P. E. C. - ALLIED LABORATORIES

Reference: Williamsburg Addition
Revised Drainage Plan
PEC File No. 36-83324-1540

Transmitted herewith are two (2) copies of the Revised Drainage Plan and accompanying support calculations for Williamsburg, an Addition to Wichita.

WILLIAMSBURG RESIDENTIAL COMMUNITY UNIT PLAN

SECTION B-B
(WEIR)

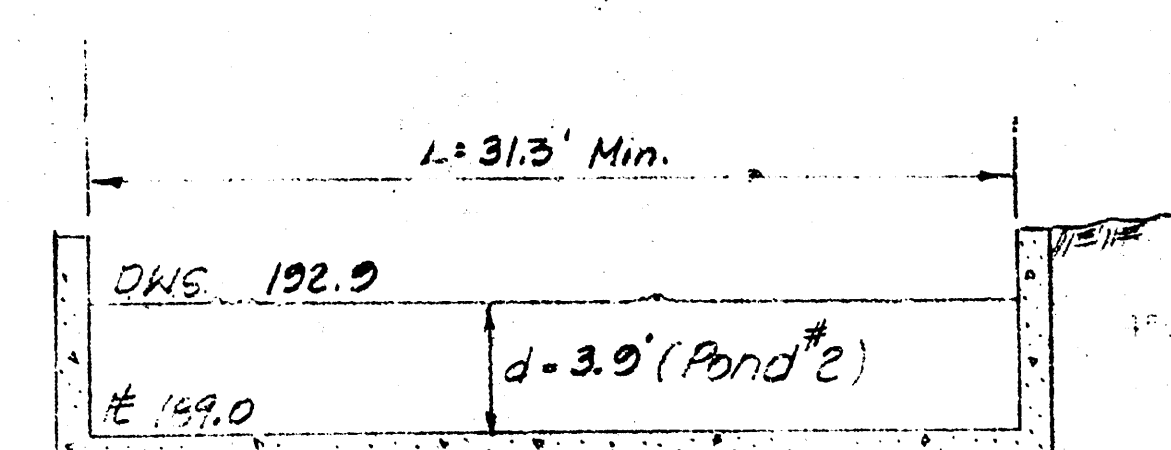
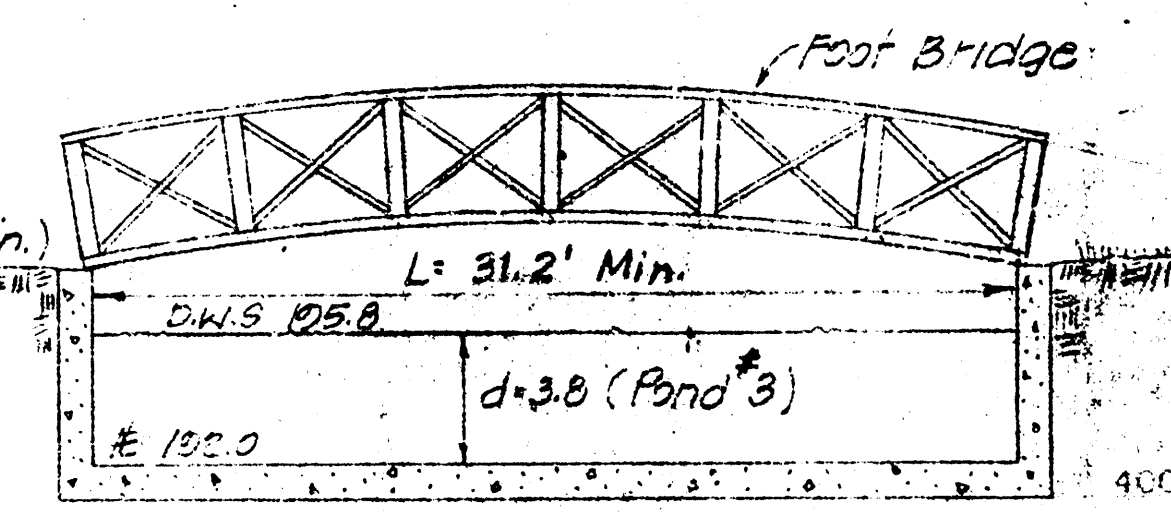
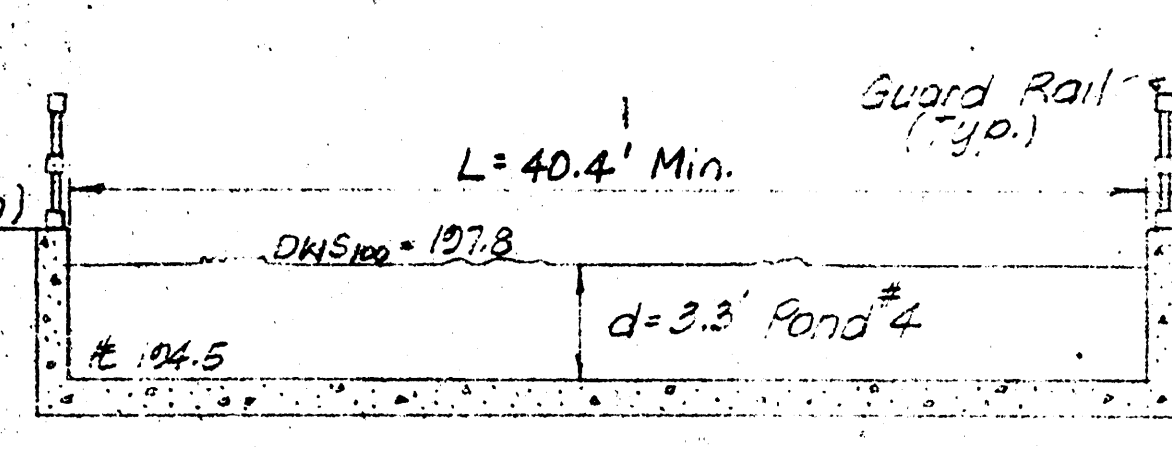
d) The required length of the weirs used as control structures for Pond No's 2, 3, and 4 have been increased. The increase in length will balance the decrease in efficiency due to the weirs being submerged. Increases range from 1.2 to 5.4 feet.

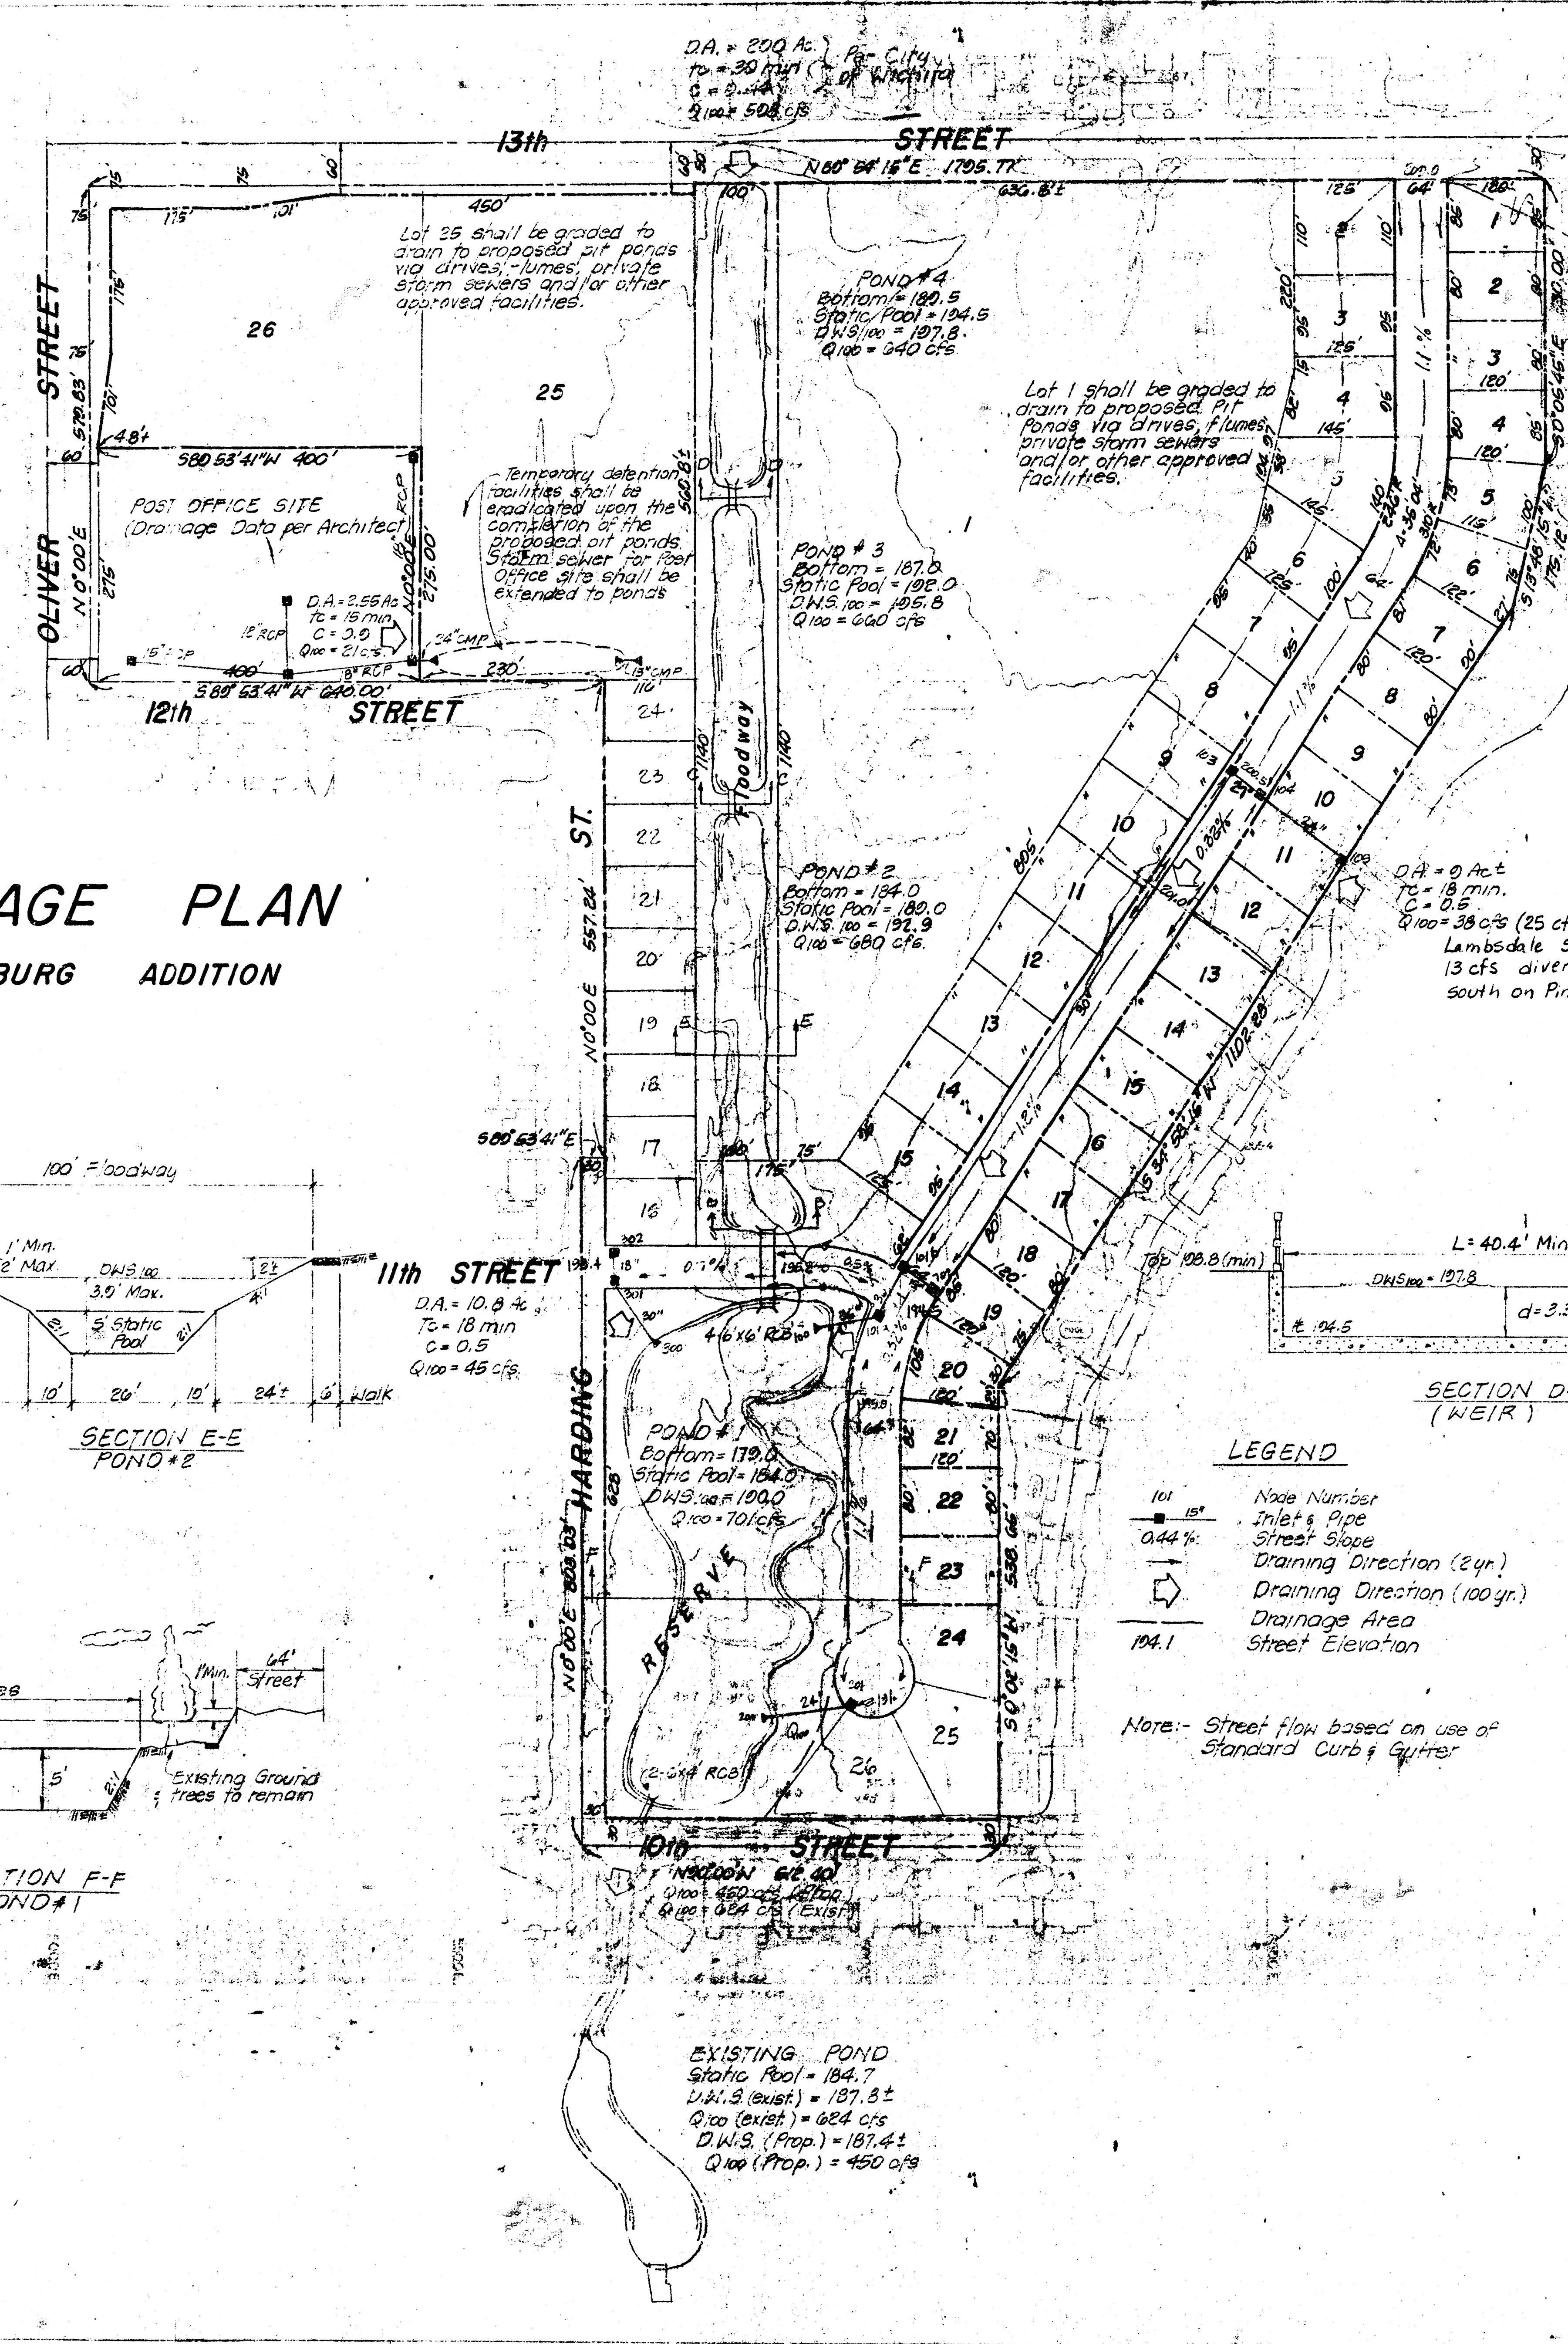
Revised 10-18-84:

- a) Lowered Pond No. 1 Elev.
- b) Added 11th St. (Rev. St. Sewers)
- c) Decreased G_{mp} from Lambdale St.
- d) Widened Weirs

Revised 7-13-84 (Lambdale St Drainage) CCB
